Access Compliance Report

Public Rights-of-Way

(Curb Ramps)

Intersection ID: 49126	Main Street: CARLOTA_CT	Cross Street: LEGOLAS_LN	Location: NE
ADA ID: E6DDF78336AE	Ramp Type: PerpDiag	Initial Pass/Fail: Fail	Overall Compliance: No
Severity Score: 58.75			
Codes/Mitigation Info/Possible Solution		Field Measurements/Component Compliance

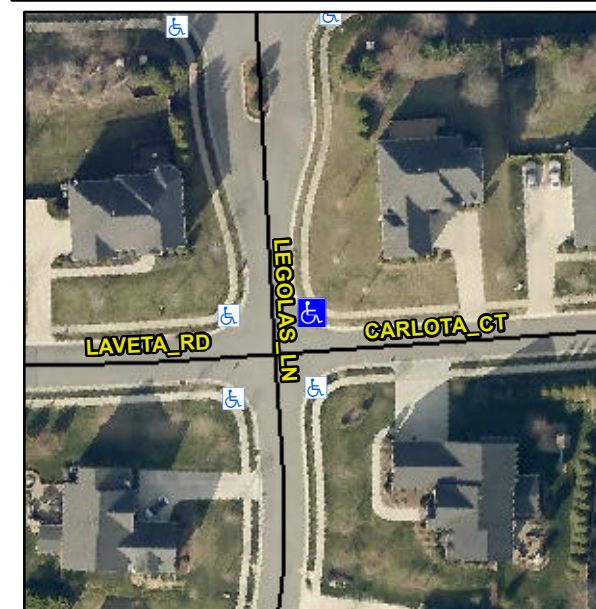
Not Found, R304.5.1, R304.2.2, R304.5.3

Compliance	Description	Data	Compliance	Description	Data
N/A	Ramp Length (in)	48.0	No	Ramp Slope (%)	12.3
No	Ramp Width (in)	37.0	No	Ramp XSlope (%)	7.2
N/A	Flare Type LT	N/A	N/A	Flare Type RT	N/A
N/A	Flare Slope LT (%)	N/A	N/A	Flare Slope RT (%)	N/A
N/A	Flare Traversable LT?	N/A	N/A	Flare Traversable RT?	N/A
N/A	Landing Length (in)	N/A	N/A	DWS Provided?	N/A
N/A	Landing Width (in)	N/A	N/A	DWS Contrast?	N/A
N/A	Landing Slope (%)	N/A	N/A	DWS Length (in)	N/A
N/A	Landing X Slope (%)	N/A	N/A	DWS Full Width?	N/A
N/A	Landing Curb? (Y/N)	N/A	N/A	DWS Offset (in)	N/A
N/A	Shared Landing?	N/A			
N/A	Gutter Ponding?	N/A	N/A	Gutter Slope (%)	N/A
N/A	Gutter Lip Ht (in)	N/A	N/A	Gutter X Slope (%)	N/A
N/A	Painted X Walk1?	No	N/A	Painted X Walk2?	No
	X Walk 1 Direction	To W		X Walk 2 Direction	To S
N/A	X Walk 1 Width (in)	N/A	N/A	X Walk 2 Width (in)	N/A
	X Walk 1 Slope (%)	5.0		X Walk 2 Slope (%)	0.3
	X Walk 1 X Slope (%)	2.3		X Walk 2 X Slope (%)	5.7

Remove & Replace Curb Ramp With Two New Directional Ramps or Equivalent.
